CALIBRES NO. 01		CS08-19-C-001-E	A
		Made by: pelrom	Date: 15.04.04

Circuit Calibre 1383

FIXING THE CIRCUIT

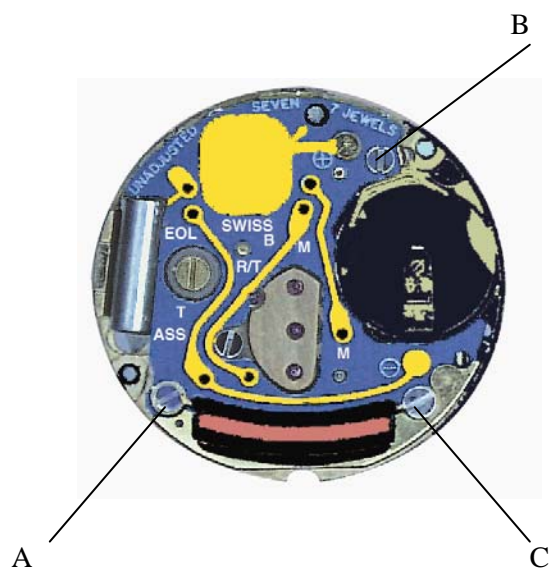
The screws must be shorter to avoid damaging the date indicator 1380/9235 in cases where the circuit cover is no longer used.

In the following table, you will find which screw must be used in which case

Calibres 1378 / 1379 / 1478 / 1479

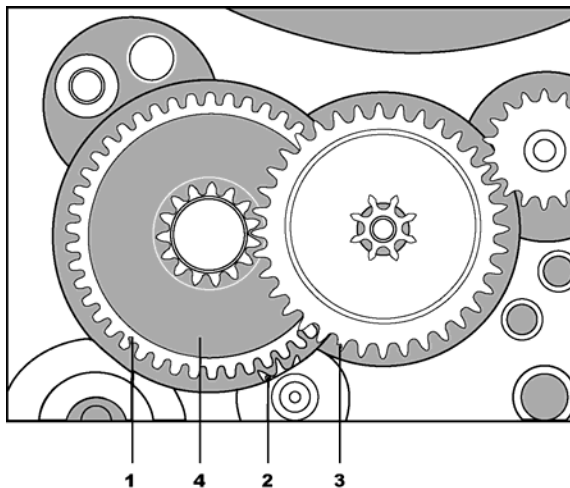
1. Risk of a lack of synchronisation between the centre wheel (1) and the third wheel pinion (2)
2. Watch stopping or losing time
3. Lower working limit exceeds 1.15 V
4. The hands touch the crystal or the dial

1. **Risk of a lack of synchronisation between the centre wheel (1) and the third wheel pinion (2).**
 - Insert a disk 1379/497 (4) (thickness 0.40mm) between the centre wheel (1) and the minute wheel (3).
 - Lower working limit.

2.3 New intermediate reduction wheel 1110/1435.

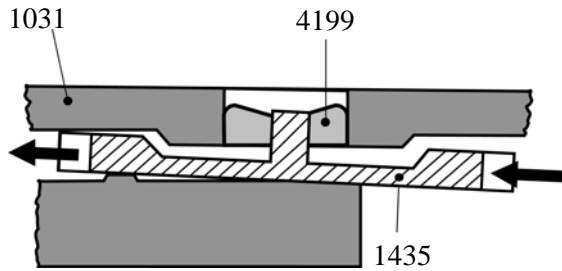
- The jewel 4199 is replaced with bushing 1547, which is driven in until level with the bridge.

- The stud of intermediate wheel 1435 should be lubricated with thick Moebius 8200 oil or D5 grease.

Figure 1

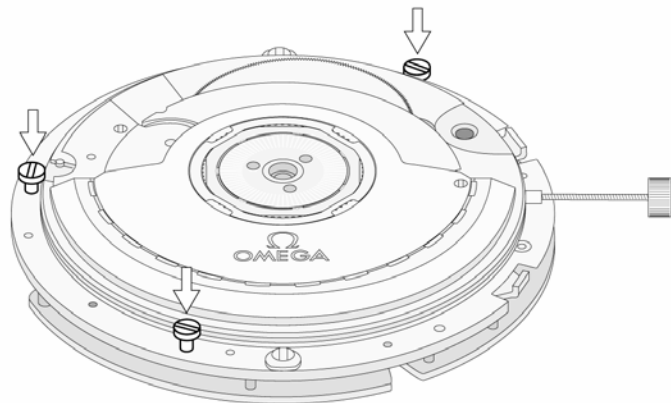
The assembling screws which attach the basic movement to the chronograph module are fragile.

Replacement of the old assembling screws by the new version (with the support washer). For all assembling screw orders, the new screws will be delivered with the support washer.

Figure 2

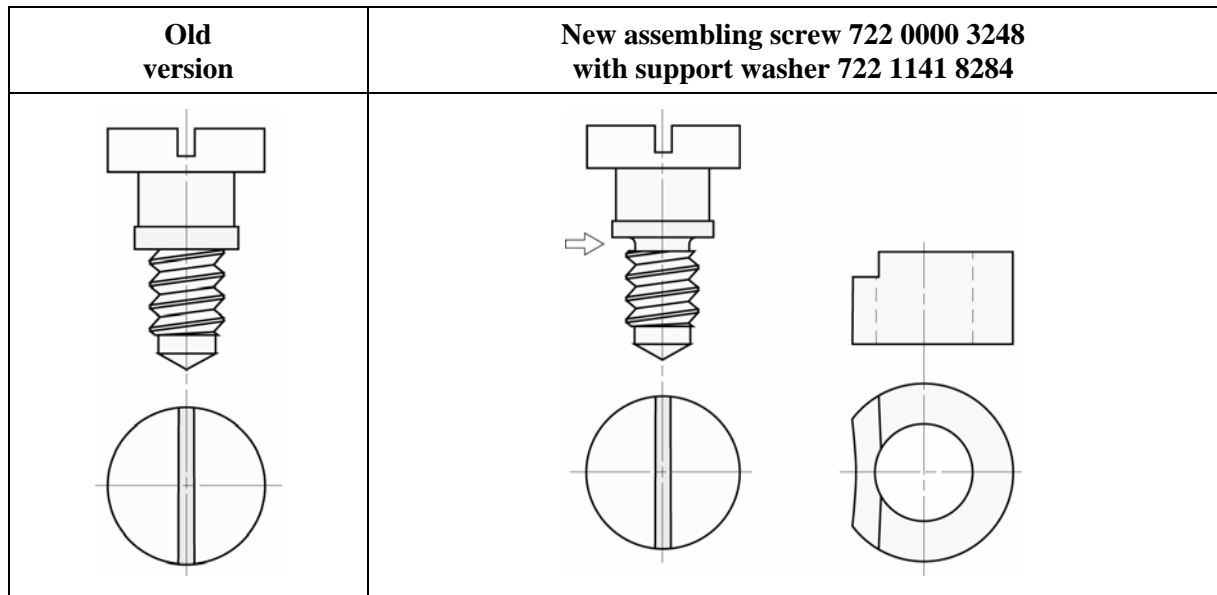
- The new screws, made of stainless steel, have a better resistance than the old screws, which were made of steel for profile turning.
- The screw has been improved by adding a groove at the top of the thread (see figure 2).
- The design has been improved by an additional support washer placed between the chronograph module and the basic movement (see figure 2 and 3).

The new assembling screw can be easily identified by the groove at the top of the thread (see figure 2).

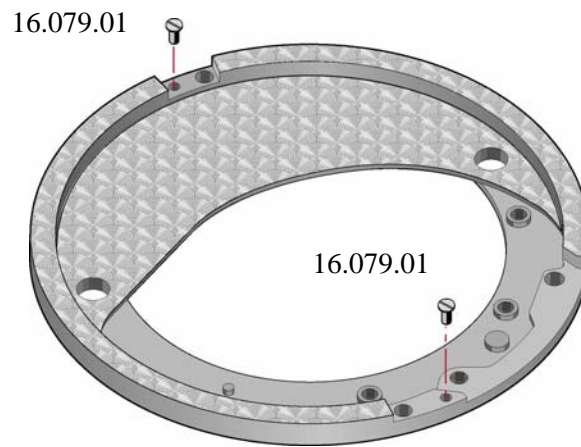
- When assembling the jumping hours module, the heads of the jumper screws for the jumping hours (no. 56.093.01), the heads of the driver screws for the jumping hours finger (no. 36.104.01), as well as the screw heads of the jumping hours mechanism plate (no. 16.079.01), may break easily when gripped. The screws 56.093.01 and 36.104.01 are identical.

- The jumper screws for the jumping hours (no. 56.093.01) have been modified to prevent the heads from breaking. The reference has not changed. If the movement is disassembled, the two screws must always be replaced by the modified screws.

Accumulator (100 days)

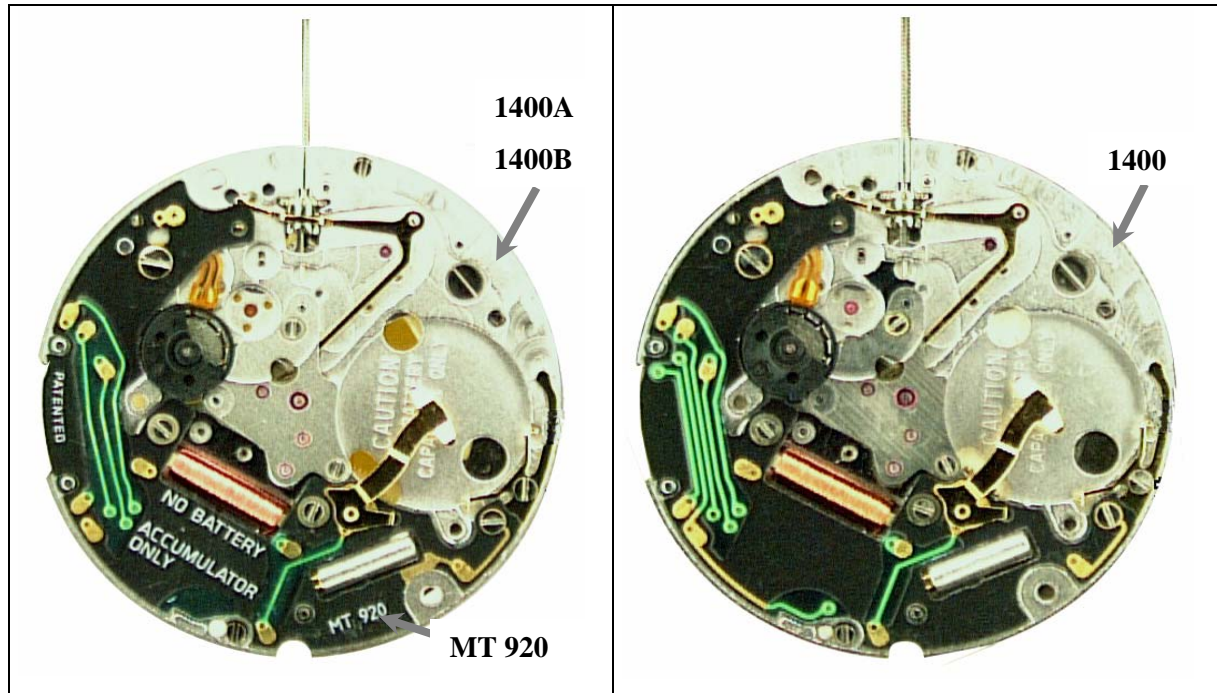
In the 100 days version an accumulator is used which can be identified by the inscription **MT 920**. The old version of 5 days used a capacitor with the inscription **GC 920**.

Capacitor or electronic module from the old 5 days version **can not** be used with new accumulator or new electronic module.

New setting wheel 1128 31.100

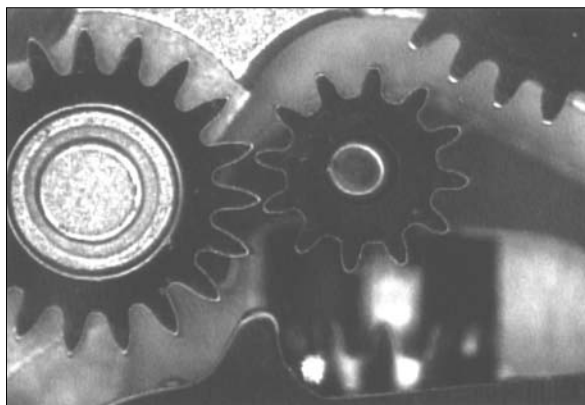
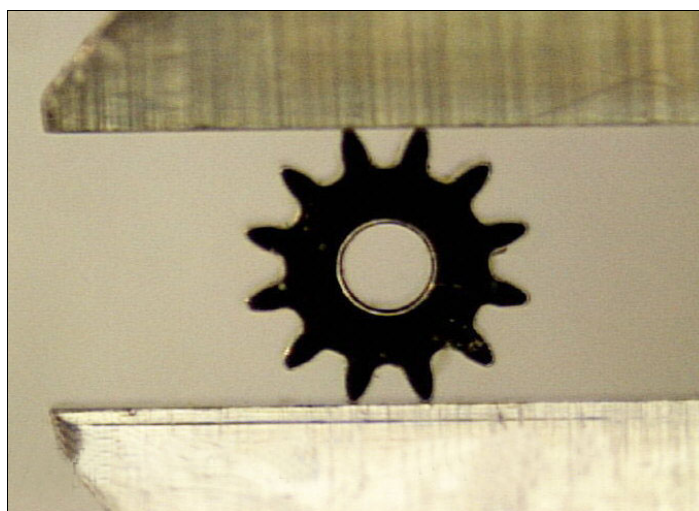
The teeth of *setting wheel 1128 31.100* are too short and provoke a butting of the gear *setting wheel - intermediate setting wheel 1120 31.101* (See picture below). As a result the upper part of *hour wheel 31.046*, which is in direct contact with the *intermediate setting wheel 1120 31.101* (via *intermediate setting wheel 1128 31.101* and an *additional wheel* riveted on *mechanism platform 1128 16.010.06*), may be momentarily blocked. Consequently, the watch owner recognises that the hour hand has lost one or more hours. The minute and second hands are, however, not affected by this failure.

A new setting wheel with longer teeth has been designed (See below picture). With the new setting wheel the risk of butting is eliminated and the problem with the lost hours resolved.

- The new *setting wheel* has a diameter of 1.54 mm (measure over 4 teeth with a sliding caliper as shown below).
- The old *setting wheel* has a diameter of 1.50 mm.

NEW FREE CANNON PINION

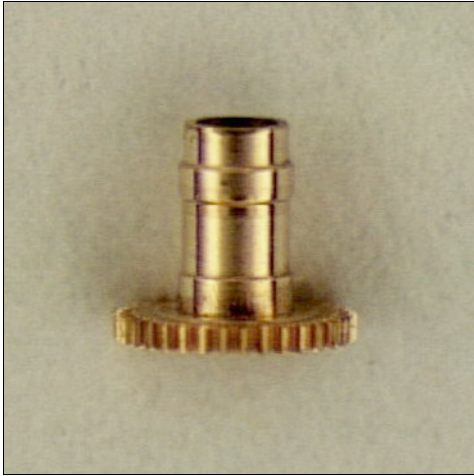
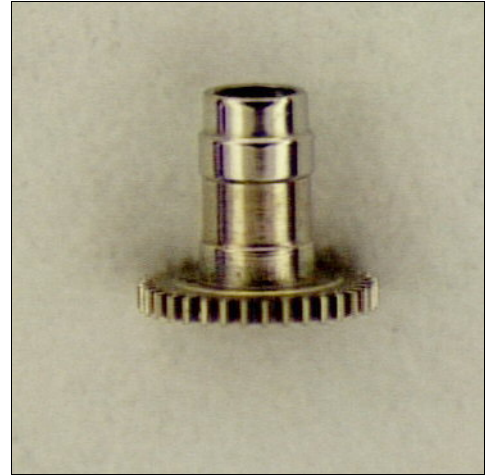
The movements have been analysed, and rusty sections between the centre tube of the chronograph module (see picture below) and the *free cannon pinion* ref. 3220 31.081P have been discovered.

Tests with the steel *free cannon pinion* and lubricants did not give satisfactory results. In order to solve the problem, a new *free cannon pinion* made of a copper-beryllium alloy has been designed.

The parts of the movements with above mentioned rusty sections have to be carefully cleaned, and the old steel *free cannon pinion* must be replaced by the new version in copper-beryllium.

The new *free cannon pinion* in copper-beryllium alloy (see picture below left), can easily be distinguished from the old *free cannon pinion* in steel (picture below right) by the difference in colour.

Modified module for 1.55 volts (silver oxide battery)

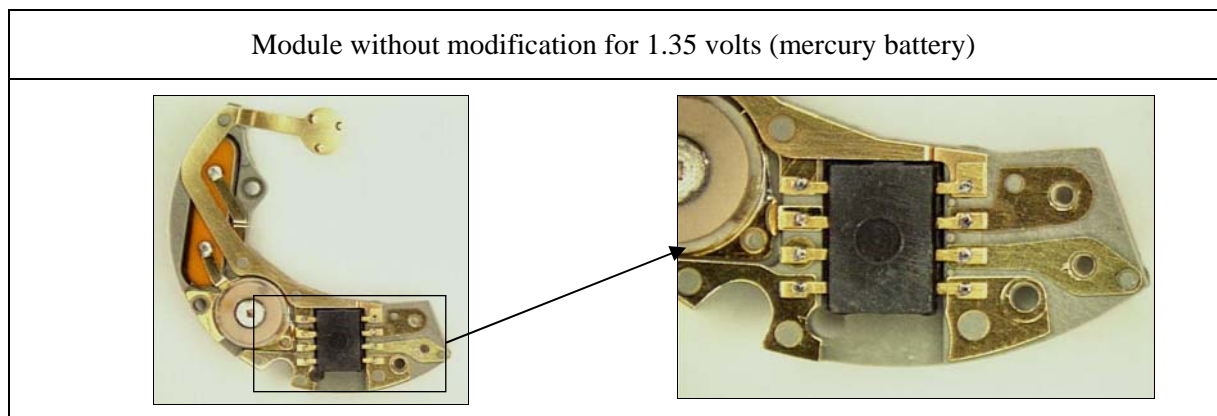
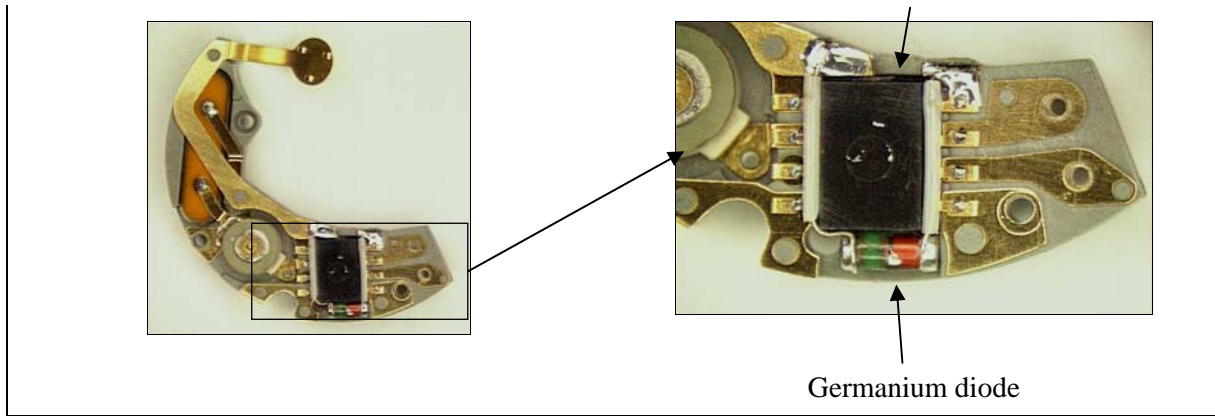
The silver oxide batteries have a voltage of 1.55 volts, whereas mercury batteries have 1.35 volts.

We have noticed that some motors on calibre 1310 stop intermittently or cease to function due to the higher voltage.

In order to power the motor with 1.35 volts and to avoid the motor stopping, a germanium diode has been connected in series between the motor and battery. This germanium diode reduces the voltage by 0.20 volts exclusively for the motor. The module continues to be supplied with 1.55 volts and can operate at this voltage without any problems.

1. HOUR HAMMER & HOUR HAMMER OPERATING LEVER

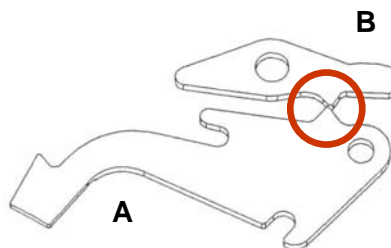
1. *Hour hammer and hour hammer operating lever*
2. *Hour counting wheel and hour counter lock*
3. *New bushings for the barrel arbor pivots*

To solve the problem, the shapes of *hour hammer* (A) and *hour hammer operating lever* (B) have been modified at the encircled place.
